City of Sandy

Planning Commission Meeting
Meeting Date: Monday, April 27,
2020
Meeting Time: 7:00 PM

| 6.1. | 19-046 MOD/VAR/DEV Sandy Vault Modification | 12 - 160 |

PRELIMINARY
UTILITY PLAN EAST
SANDY SELF STORAGE
SANDY, OREGON

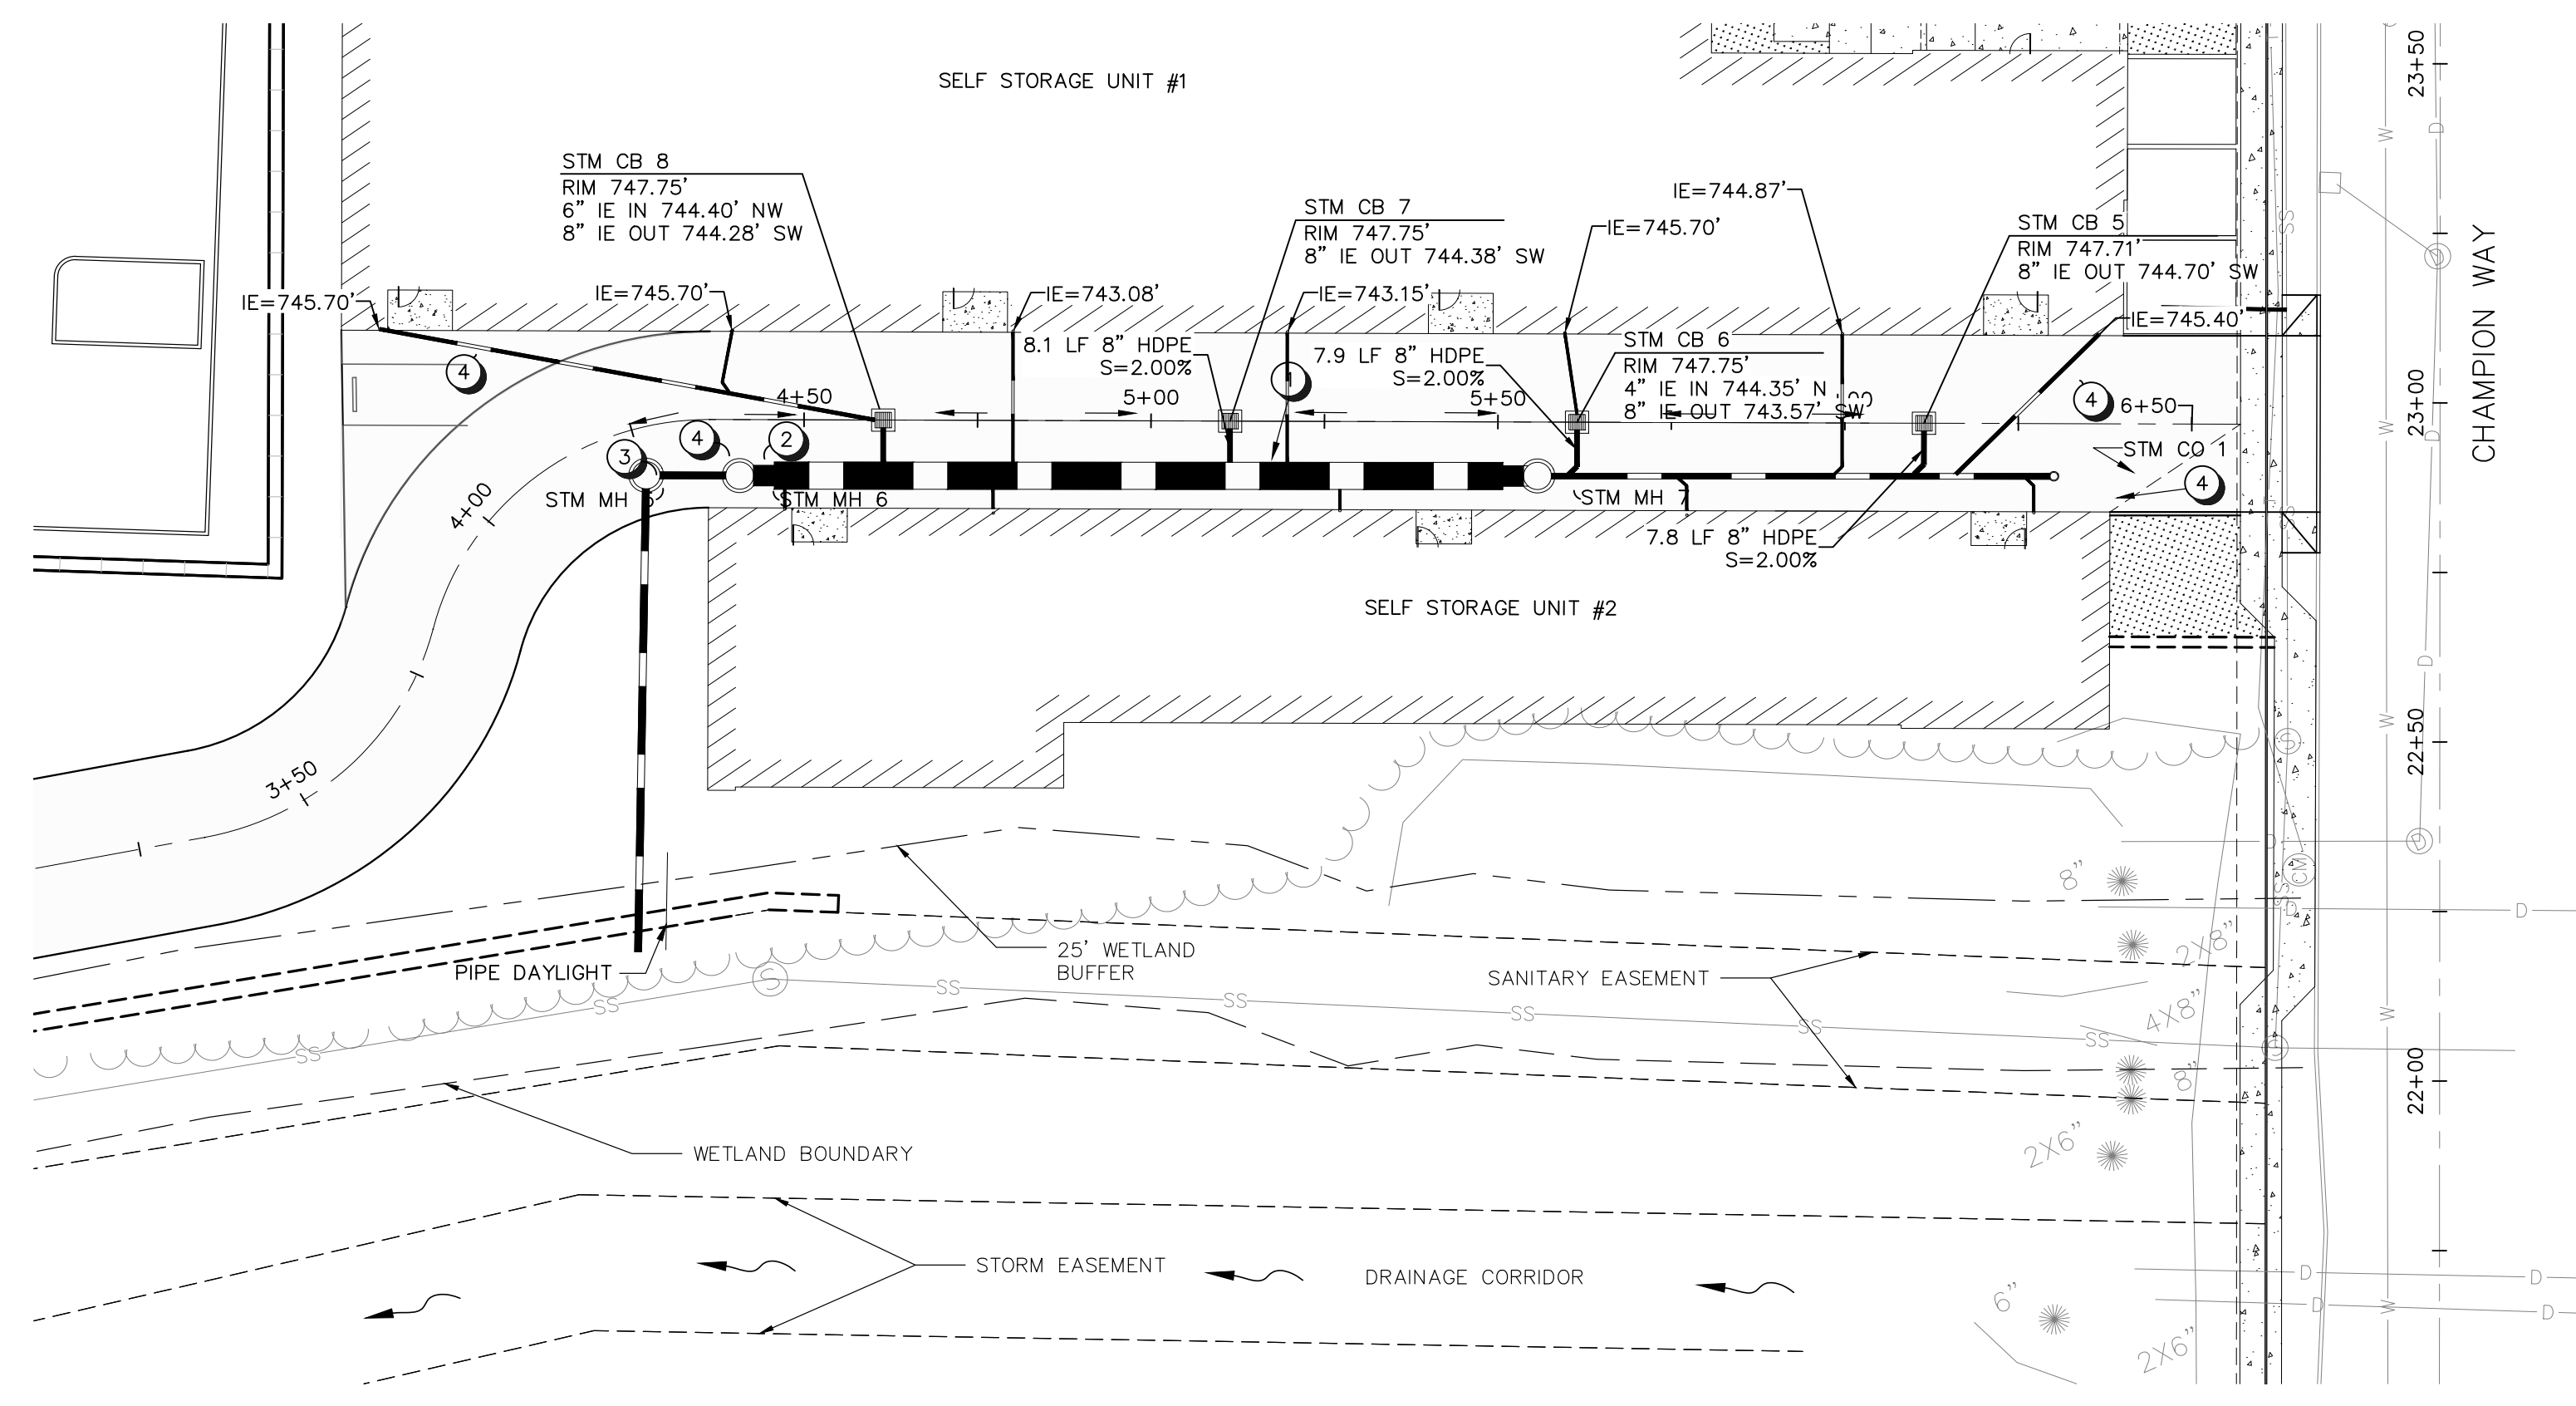
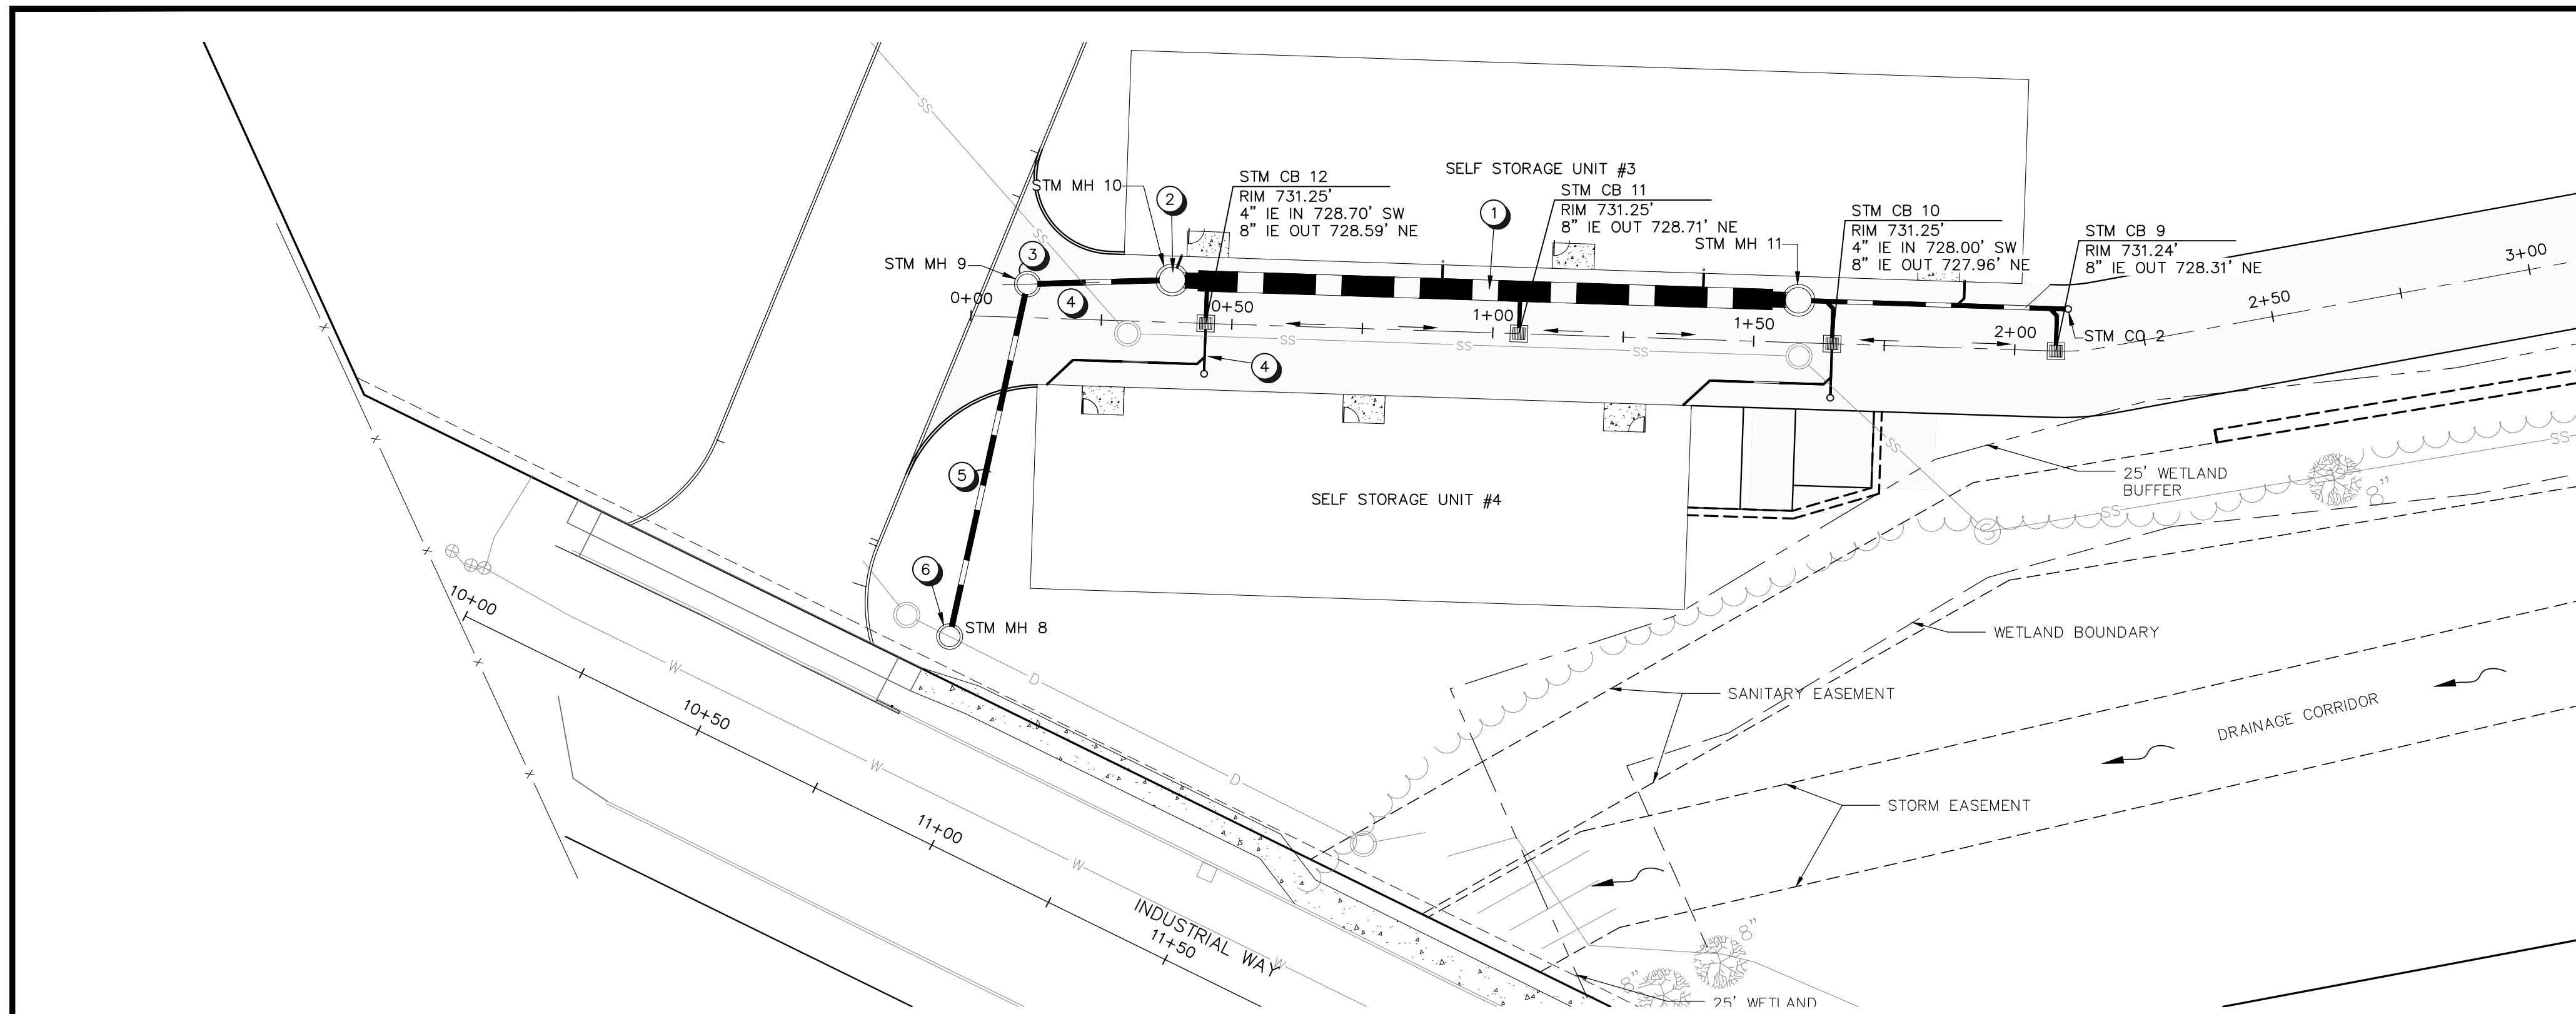
Per the Public Works Director (Exhibit M), the Utilities Plan East (Exhibit C, Sheet 8) shows a water service connected to the private water main in the common access easement. Water service laterals may only be connected to public water lines. **The water service for the site shall be connected to the public water main in Champion Way.** The Utilities Plan also depicts a sewer lateral connected to the existing private sewer main in the common access easement. **The applicant shall sign and record a sewer maintenance agreement reviewed and approved by the City for multiple properties under separate ownership served by a private common sewer line. All stormwater detention and treatment shall conform to the requirements of Sections 13.18 and 13.20 of the SMC and the City of Portland Stormwater Management Manual (SWMM). Prior to beginning design on the utility service lines the applicant shall consult with Sandy Fire District regarding fire hydrant locations and spacing on the site.**

A-101

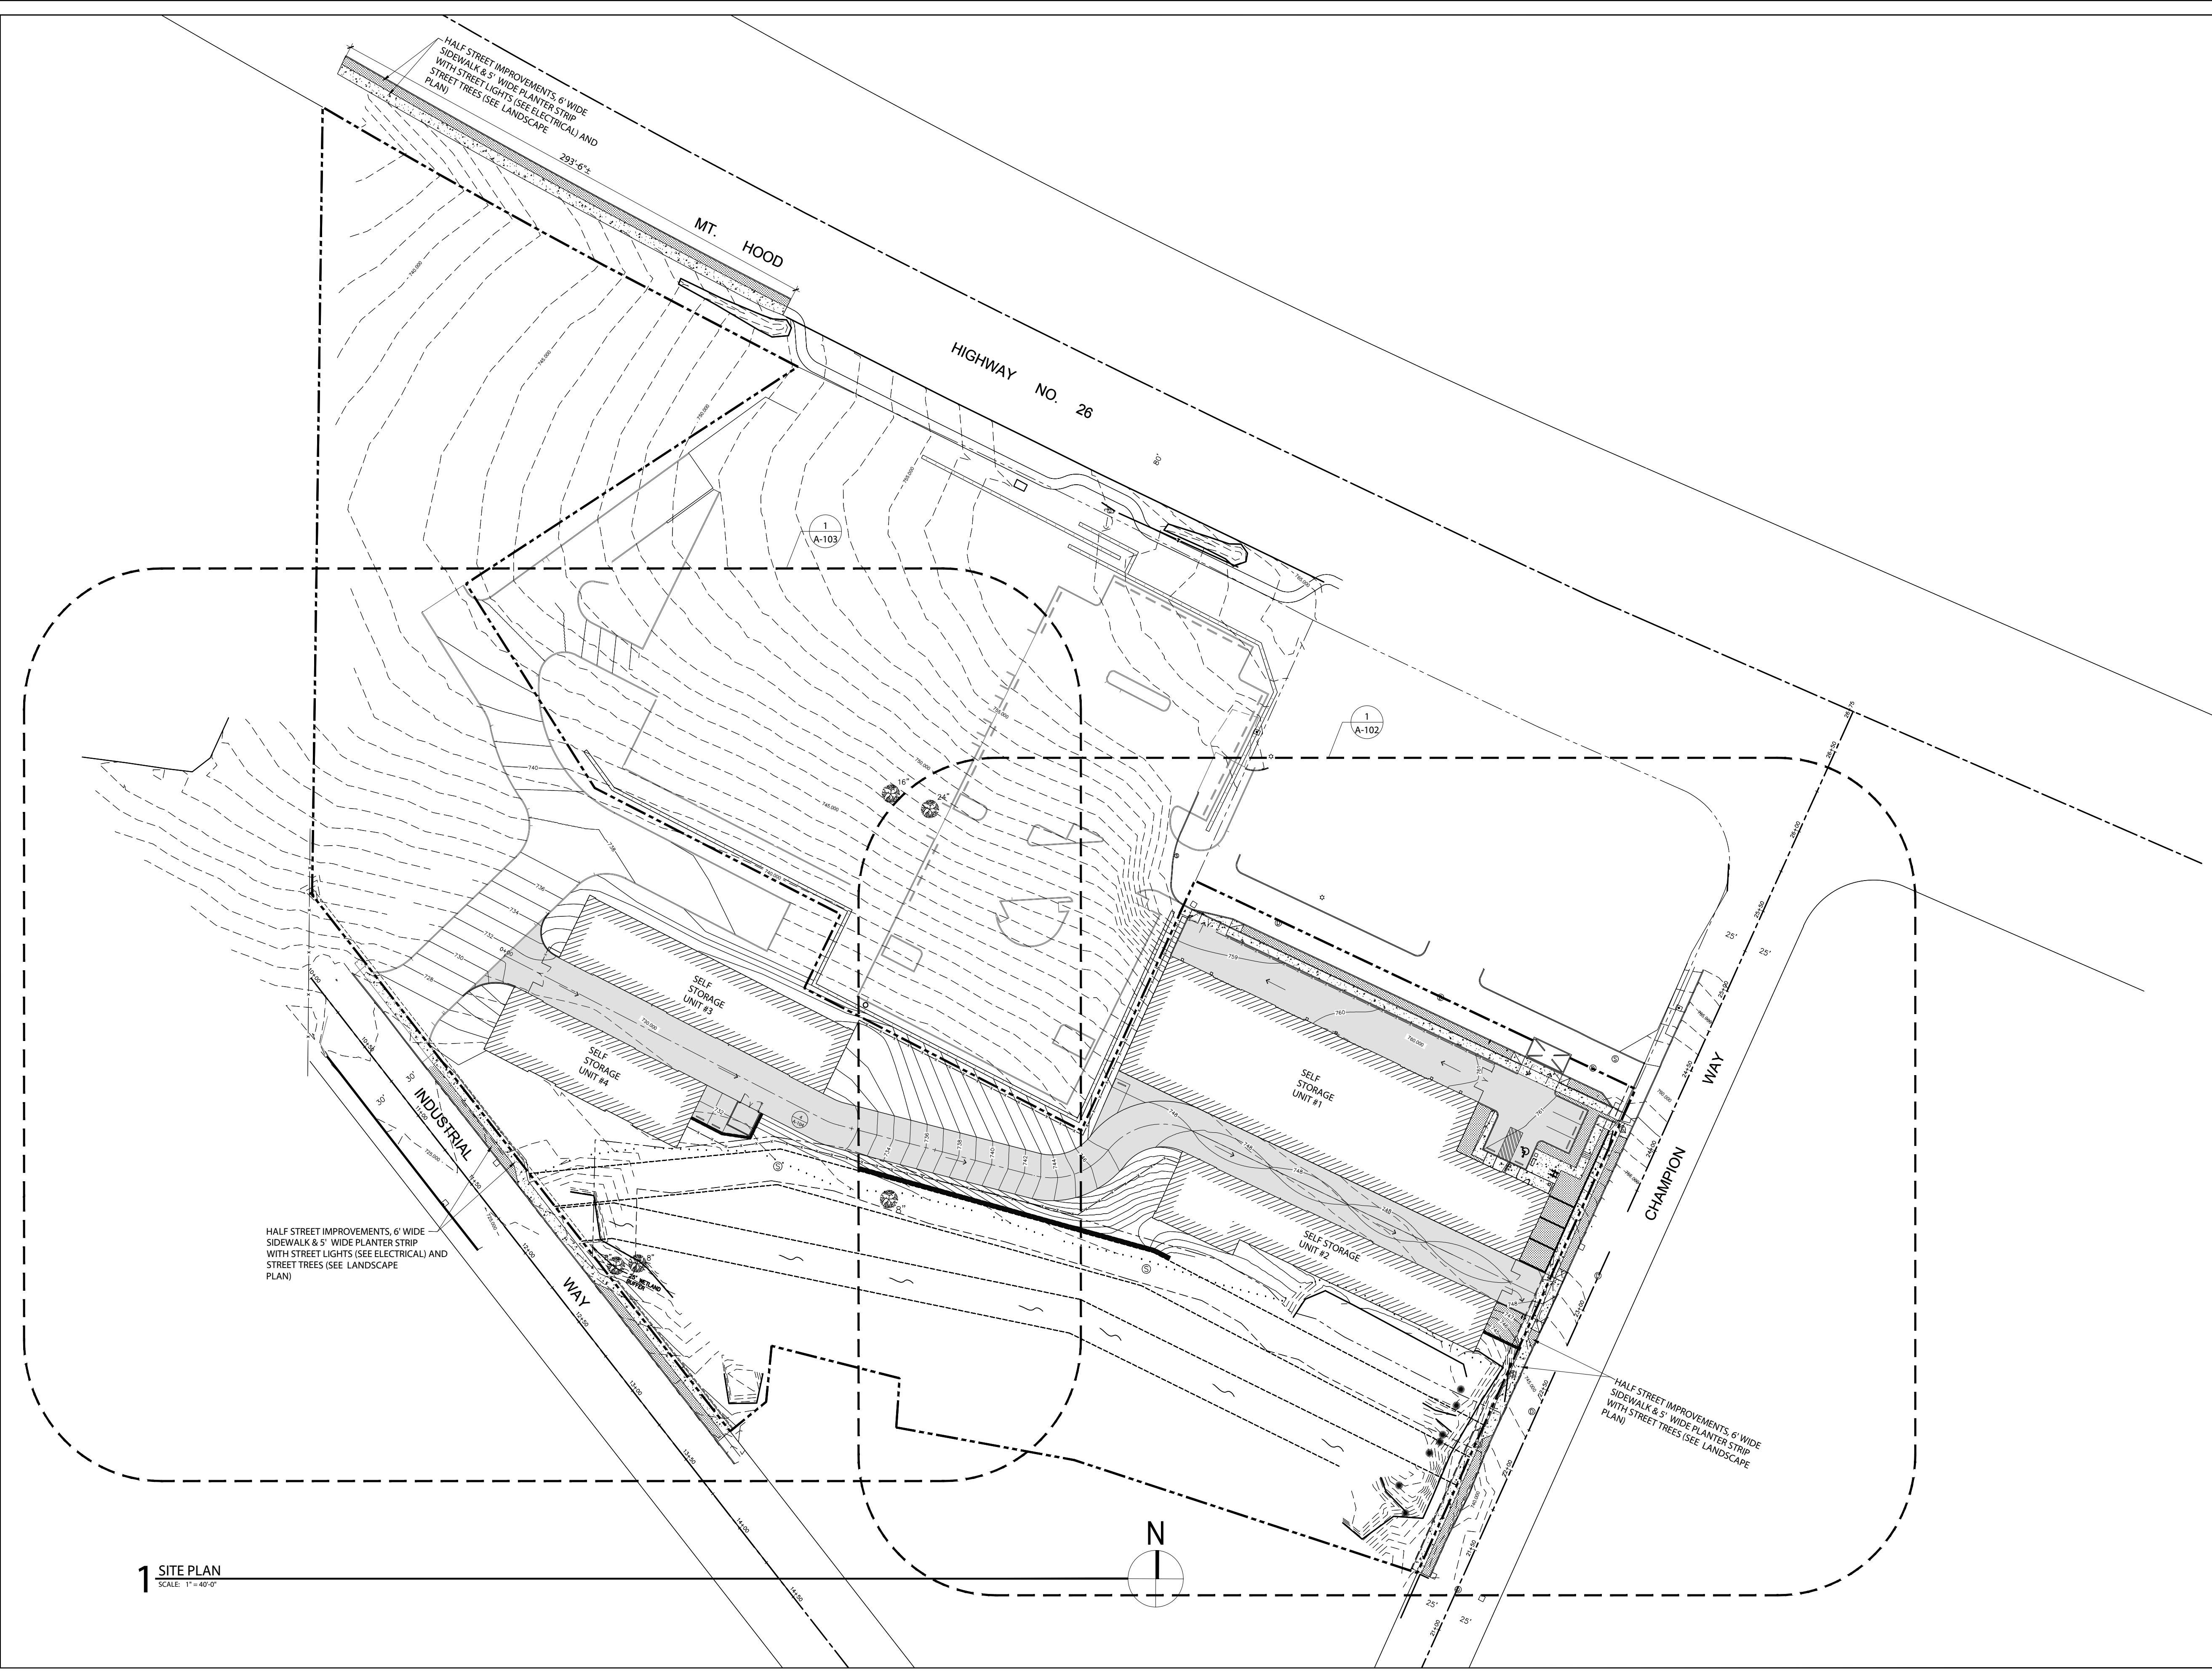
The submitted Site Plan (Exhibit C, Sheets 3A and 4) details two additional retaining walls: one south of the proposed driveway between Buildings 2 and 4, and a second north of Building 3. Both proposed walls are located in the side yard and, therefore, shall not exceed 8 feet. The applicant did not submit details on either proposed retaining wall so staff does not know the heights of these walls. **The applicant shall submit details on all proposed retaining walls on the subject property, including wall height and proposed architectural finish for staff review and approval. If the wall between Buildings 2 and 4 or the wall north of Building 3 exceeds 8 feet in height, the applicant shall apply for an additional variance.** At the March 19, 2019 Planning Commission hearing, the applicant indicated that there is a retaining wall south of Buildings 2 and 4 that is proposed to be two (2) feet in height.

setback from the Highway 26, Champion Way, and Industrial Way public rights-of-way. There are no buildings proposed along the Highway 26 frontage. The Site Plan (Exhibit C, Sheets 3A and 4) depicts all proposed buildings at 20 feet (or greater) from the Champion Way and Industrial Way rights-of-way.

17. Section 17.84.30(A) requires setback sidewalks with a minimum width of six feet along arterial streets such as Highway 26, and collector streets, such as Champion Way and Industrial Way. The Site Plan (Exhibit C, Sheets 3A and 4) depicts new 6 foot sidewalks with a 5 foot planter strip along the site frontage of both Champion Way and Industrial Way. There are existing 5 foot wide sidewalks on the Highway 26 frontage of the site. Highway 26 is a major arterial; therefore, 6 foot wide sidewalks are required. **ODOT (Exhibit N) recommends that the applicant be required to bring the sidewalk up to current City and ODOT standards. Sidewalk and planter strip shall be constructed as necessary to be consistent with local, ODOT and ADA standards. The applicant shall obtain all appropriate permits and agreement to work in the ODOT right-of-way (see Exhibit N).** The Site Plan (Exhibit C, Sheet 3B) indicates the applicant will remove the existing 5 foot sidewalks and install 6 foot wide sidewalks along the Highway 26 frontage of the site that will match the approved Tractor Supply sidewalk alignment. Per the Public Works Director (Exhibit M), **the applicant shall provide pedestrian improvements on all site frontages (Champion Way, Industrial Way, and Highway 26) consisting of a five-foot planter strip and six-foot sidewalks per Sections 15.28 and 17.84.30 of the Sandy Municipal Code (SMC). Street trees approved by staff are required in the planter strips at 30 foot on-center spacing. In addition, street lighting shall be required at the west end of Champion Way where there are currently no streetlights (approximately 400 lineal feet) and the west end of the Highway 26 frontage (approximately 300 lineal feet).**

80. Section 17.98.60(B) contains standards for the size of parking spaces. The Site Plan (Exhibit C, Sheets 3A and 4) identifies seven (7) parking spaces total. The five (5) parking spaces located near the office in Building 1 are standard parking spaces at 9 feet by 19 feet, including 1 ADA parking space, and the remaining two (2) parking spaces located east of Building 4 are 10 feet by 20 feet. The ADA parking space is detailed with the aisle on the driver’s side. **The applicant shall update the plan set to detail the ADA parking space with the aisle on the passenger side. Signage associated with the ADA parking space shall meet the head clearance distance requirement in the Building Code.**
